RE: REVISED DRAINAGE PLAN FOR 28-UNIT APARTMENT COMPLEX FOR DON KEITH & ASSOCIATES (K-13/D15) RECEIVED JUNE 18, 1985

RE: Hydrology Project No. K13/D15 - Request for variance to Provide Alley Grades.

RE: K13/D15 -Revisions per letter of May 29, 1985 (BJG/BJM/cl)

REF: DRAINAGE PLAN FOR THE 28-UNIT APARTMENT COMPLEX FOR DON KEITH AND ASSOCIATES (K13/D15) RECEIVED MAY 9, 1985

TITLE: SIDEWALK CULVERT DETAIL
DON KEITH APARTMENTS
1021 COAL AVE. S.W.

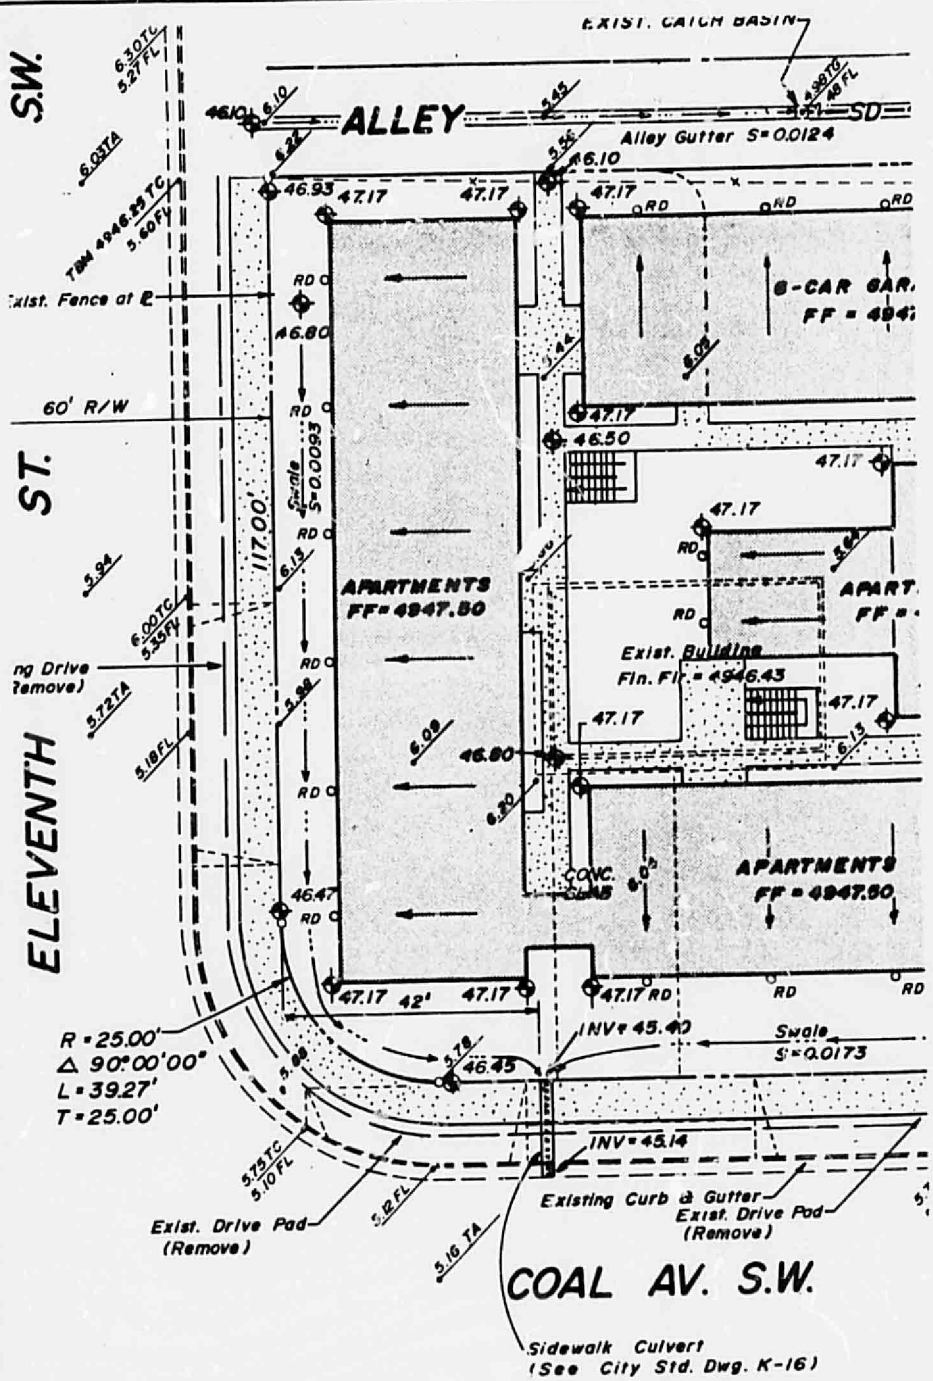
9. All your roof drains that are located adjacent to the public sidewalks will not be allowed to sheet flow across the sidewalks (Provisions must be made to route the developed run-off onto the paved areas from the majority of the roof drains).

9. A swale and sidewalk culvert have been added to the plan so that roof drainage does not cross the sidewalk.

GRADING & DRAINAGE PLAN

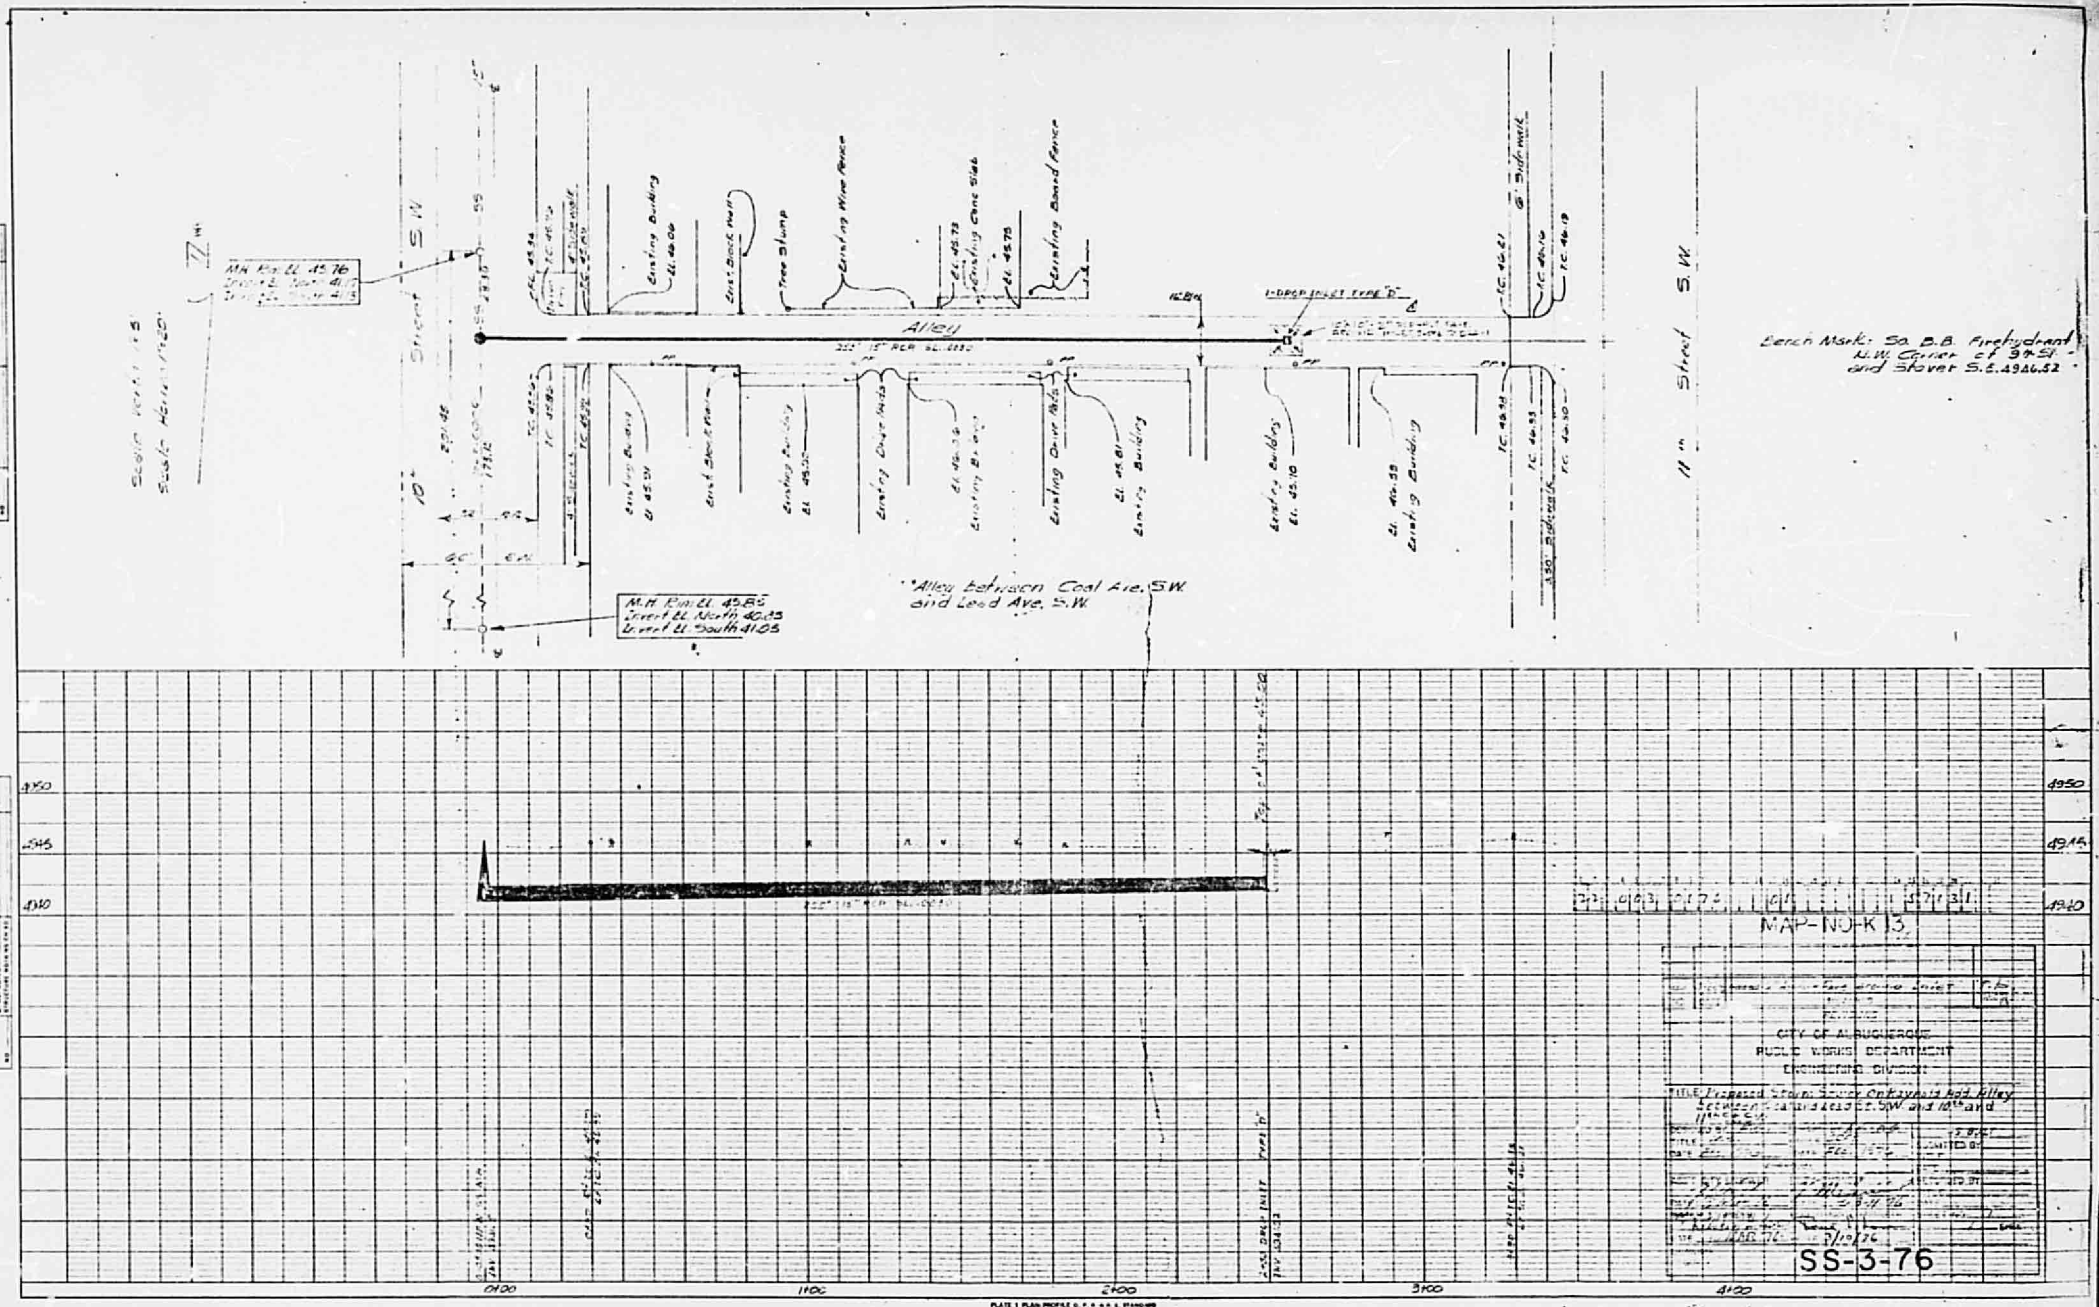
1. New information sheet with resubmittal designation.
2. Engineer stamp with signature and revision date.
3. Erosion control plan for duration of construction.
4. Please address any off-site flows if any.
5. Downstream capacity must be justified with calculations and by means of existing storm line capacities. what is the catch basin capacity and how much is contributing?
6. City Engineer approved alley grades are required.
7. Elevation of property line at least .33' above adjacent top of curb.
8. Please indicate the 100-year flood hazard encroachment on your plan.

10. What amount of developed flows will be contained in the interior court yard?

11. Location of T.B.M. within site area.

4. Off-site flows are accepted as shown on the plan.

5. Downstream capacity is justified as shown in the revised calculations.

7. The elevations at property line have been raised to be a minimum of 0.33 feet above top of curb.

8. The 100-year flood hazard encroachment can only be estimated since it is an A.O. zone and no base flood elevation is shown, only a depth of 1 foot. It is assumed this is the depth above the lowest point on the flow line (45.10 + 1.0 = 46.10). This approximate limit has been shown.

10. The amount of developed flows in the court yard area are 0.3 cfs. However, spot elevations have been added to show that this flow will drain to the alley by means of the sidewalk . Low flows that would occur in winter when icy conditions occur

will be retained in the grass court yard.

11. The T.B.M. is located at the N.W. Corner of the Site, top of curb elevation 4746.25.
